Discretionary Review Abbreviated Analysis HEARING DATE: OCTOBER 3, 2019

Date: September 20, 2019
Case No.: **2019-013111DRP**
Project Address: **240 Chenery Street**
Permit Application: 2019.0513.0493
Zoning: RH-2 (Residential House, Two-Family)
40-X Height and Bulk District
Block/Lot: 6685 / 049
Project Sponsor: Edward Gama
2261 Market Street # 600
San Francisco, CA 94114
Staff Contact: David Winslow – (415) 575-9159
David.Winslow@sfgov.org
Recommendation: **Do not take DR and Approve**

The project proposes to construct windows at an interior property line to a previously permitted construction of 3-story, one-family dwelling at the street front.

PROPOSED NORTH ELEVATION

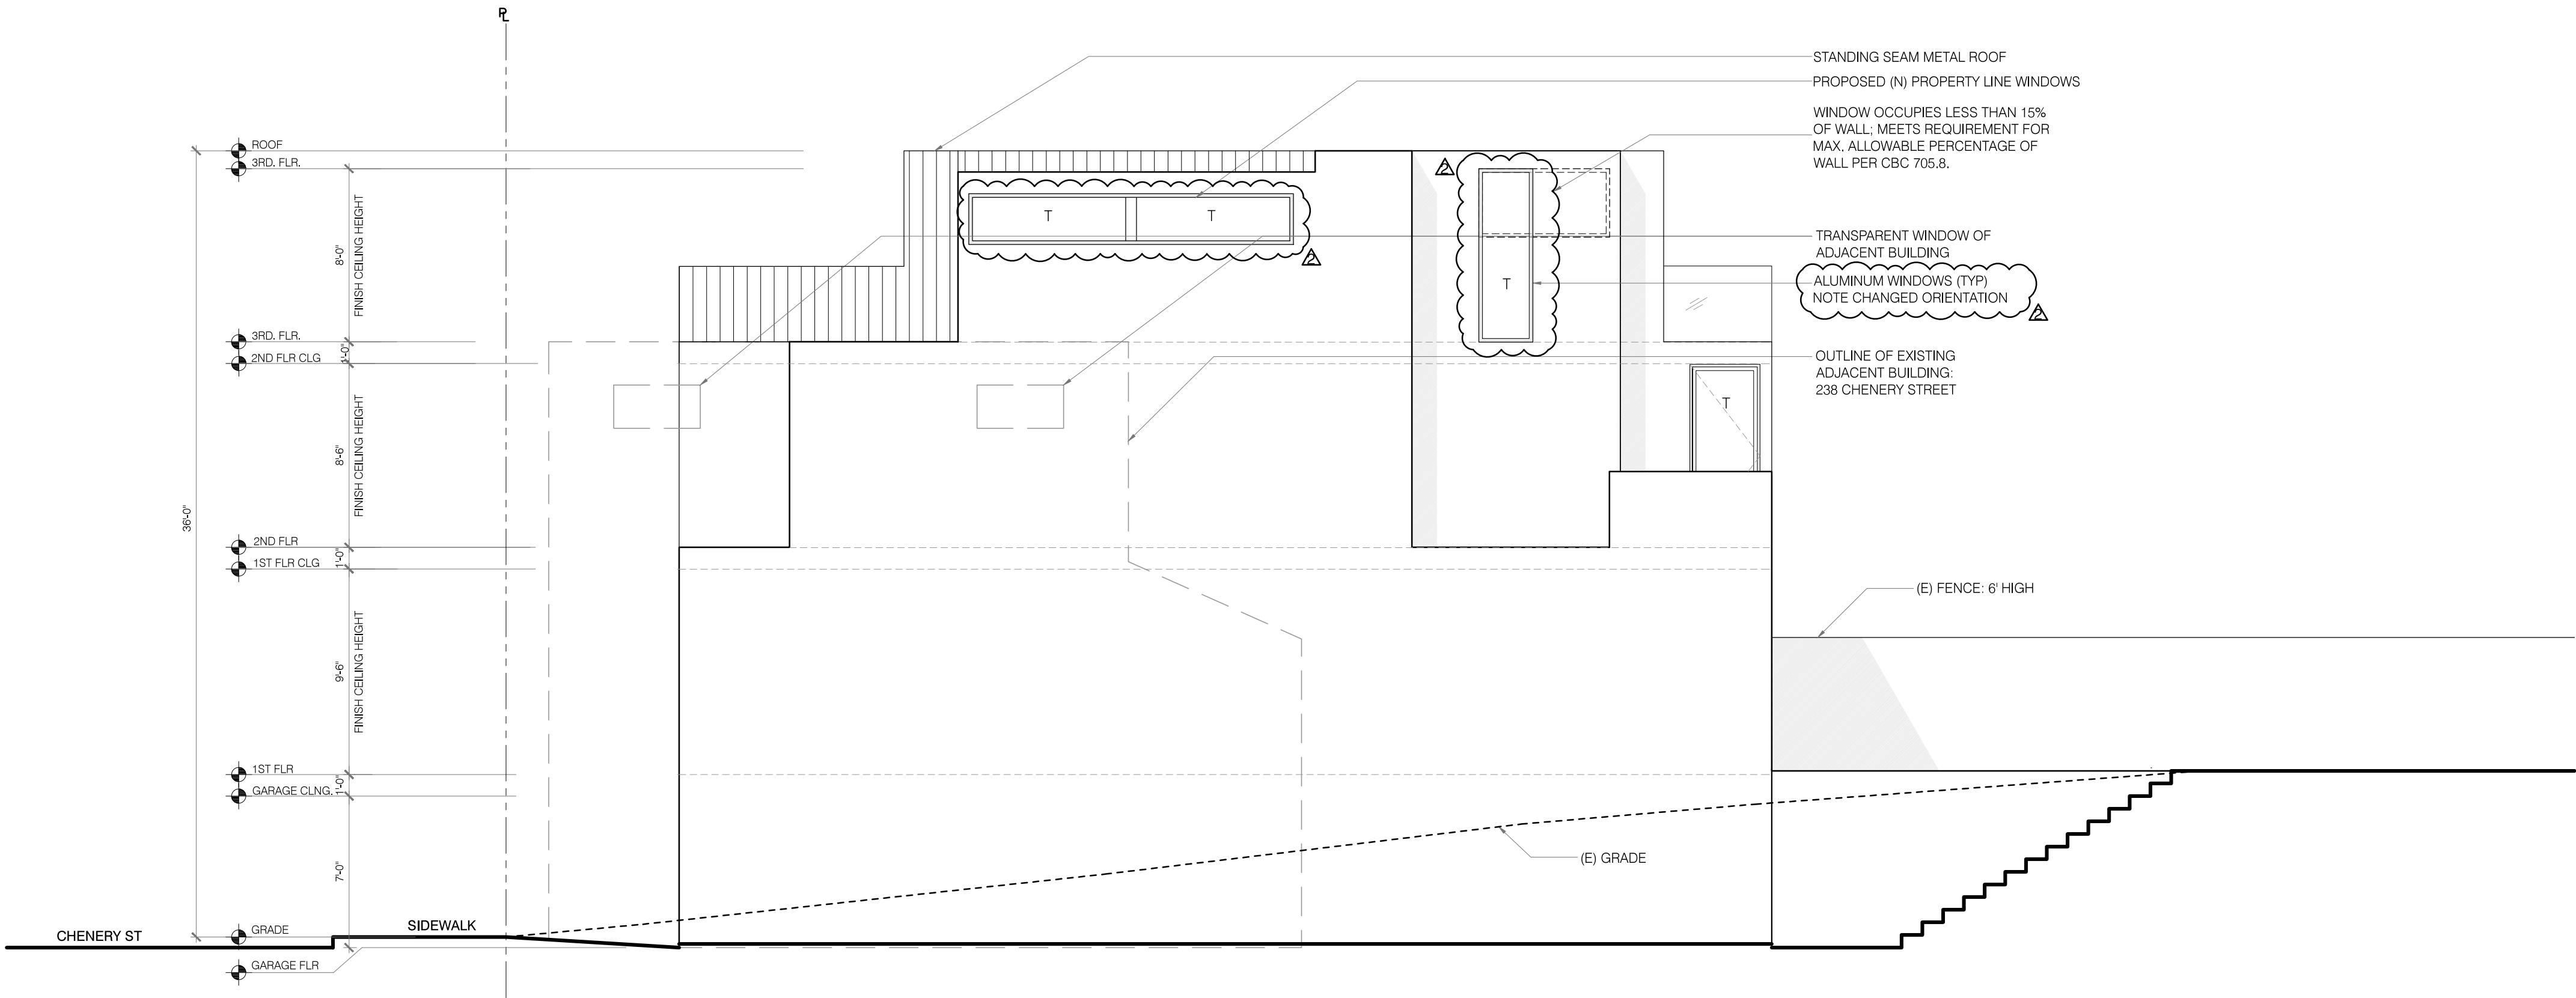
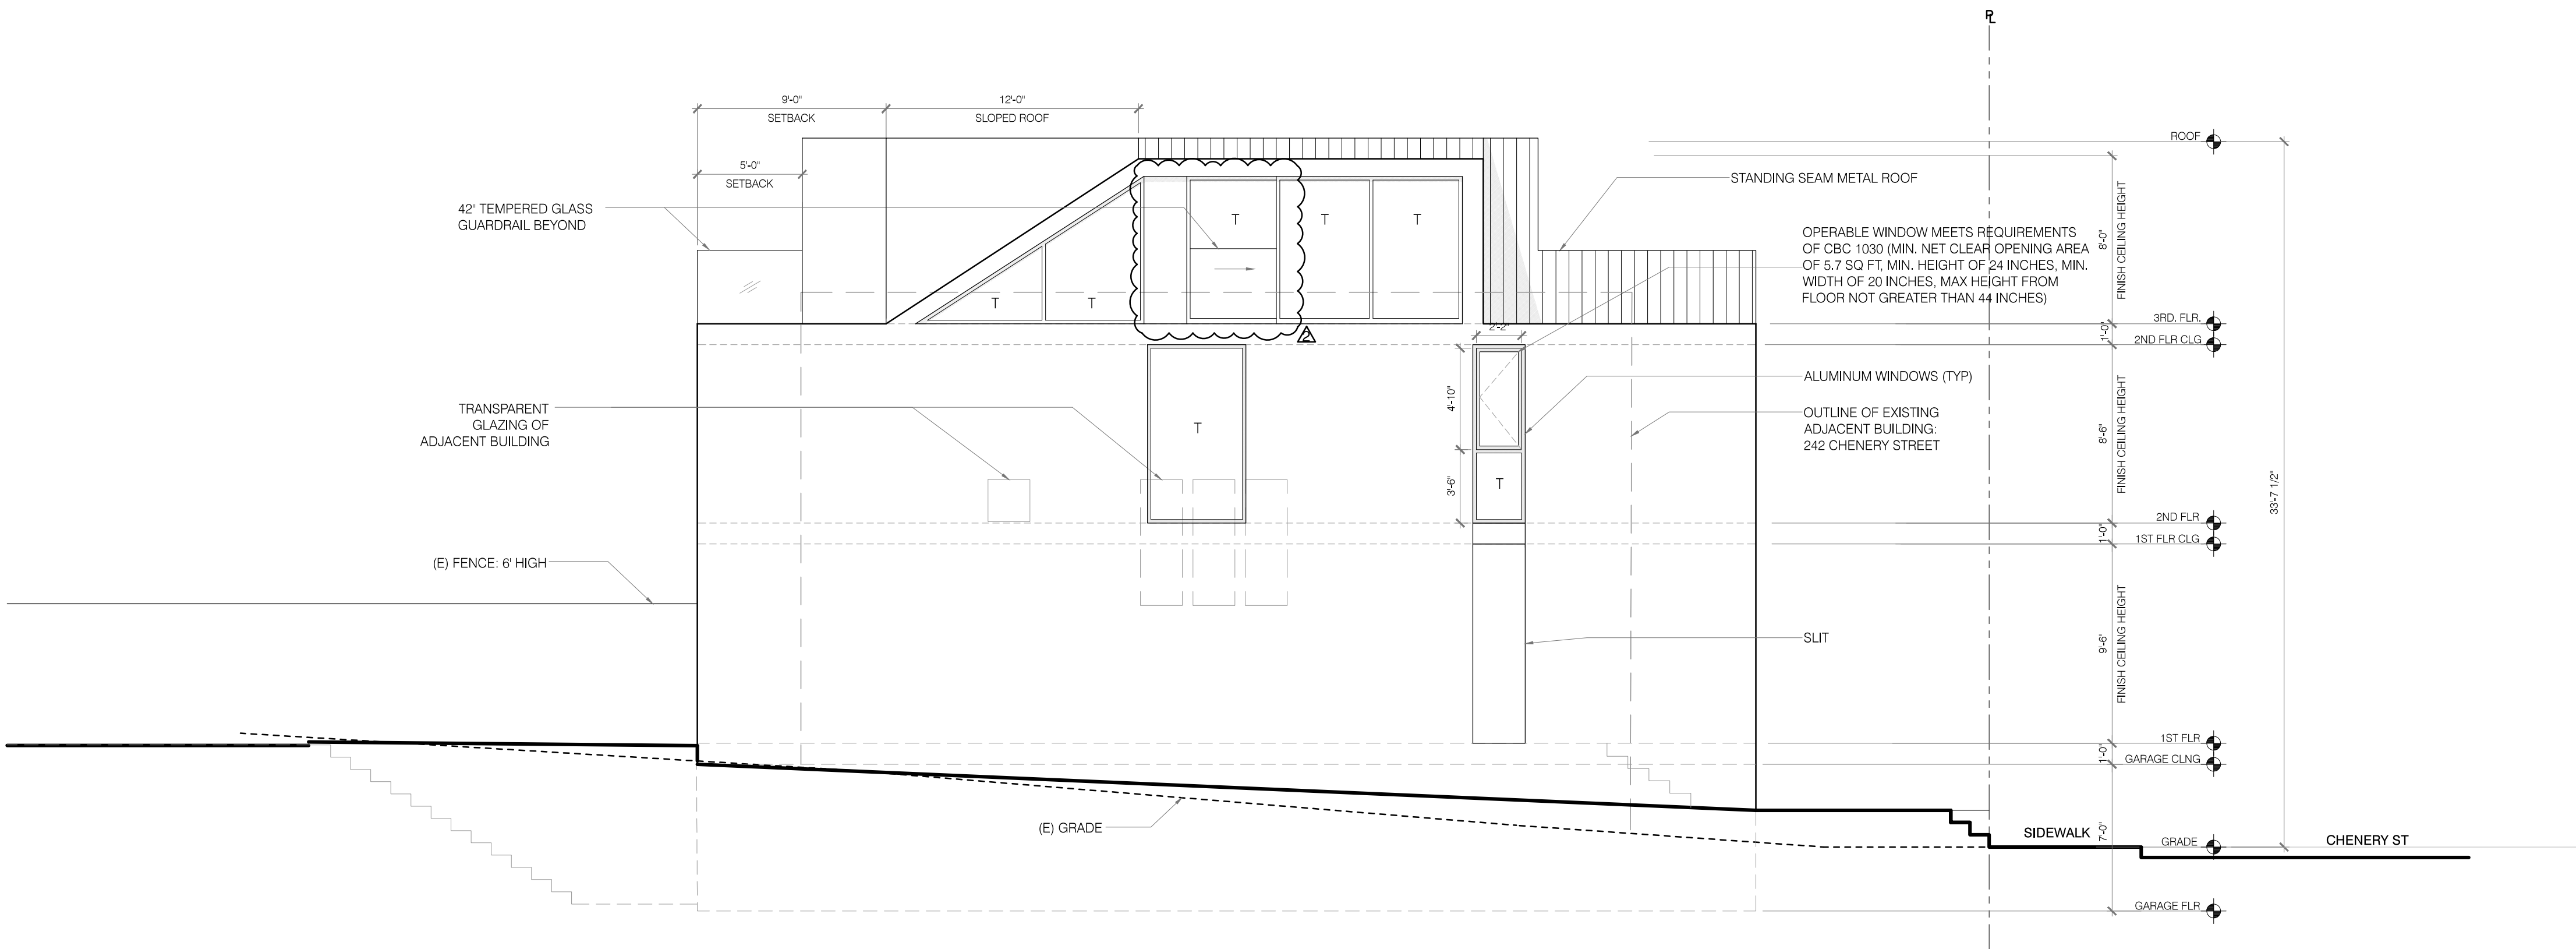
1. The size and materials of the windows are unknown;
2. The property line windows would create privacy impacts.

The proposed windows look over the roof of the neighboring property and do not look directly into the neighbor's windows or yard.

RDAT found that the proposed property line windows do not diminish privacy to any spaces of the neighbors property.
